OCPP 2.1 Edition 1
Errata 2025-11

2.14. Page 119 - (2025-11) - C15 - Offline Authorization of unknown Id - Scenario description

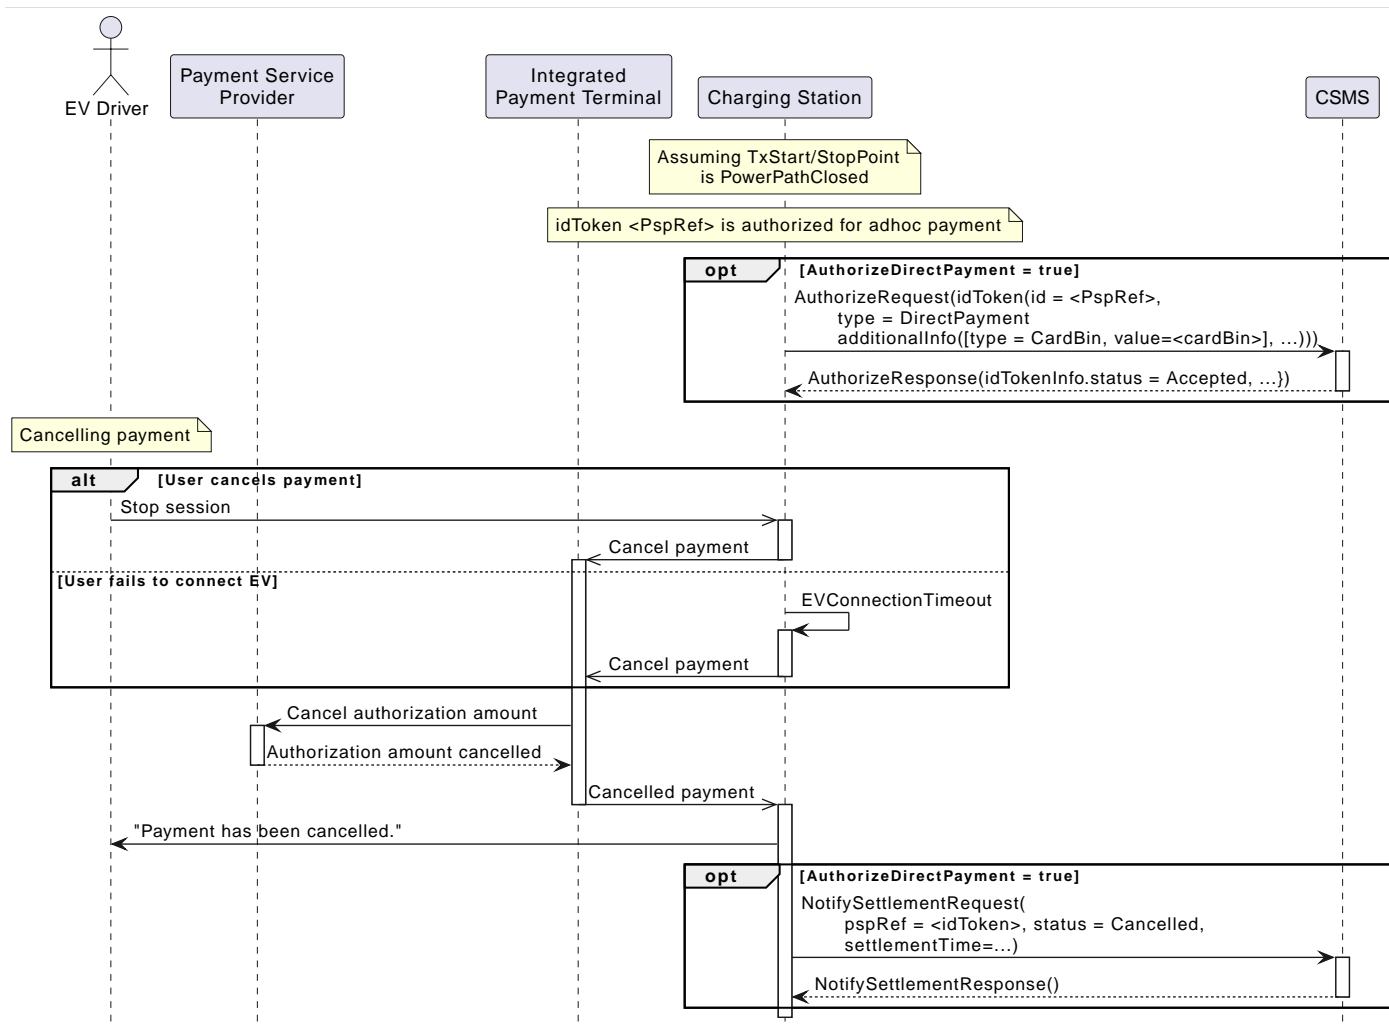
In the Scenario Description, points 2 and 3 have been reversed, placing the Local list above the cache in terms of precedence.

Sequence Diagram: Cancel Reservation

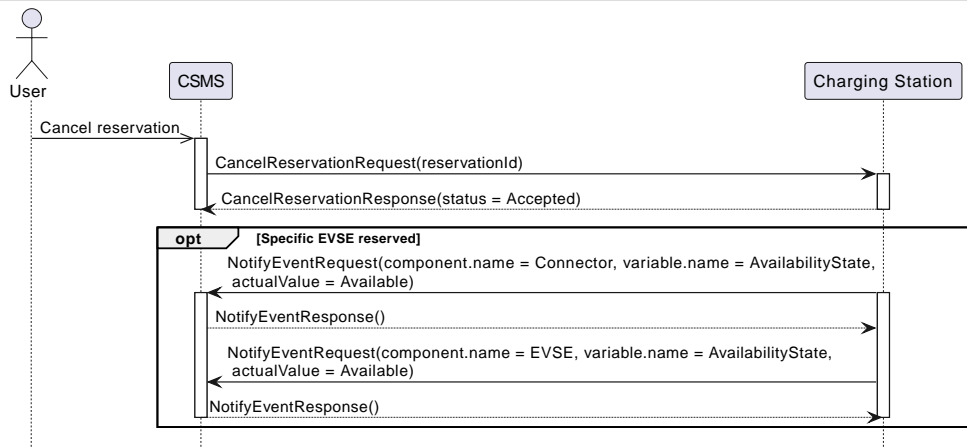
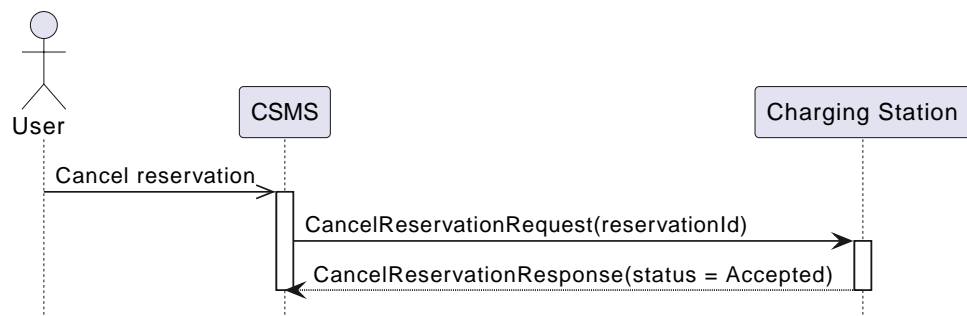
Removed details from sequence diagram
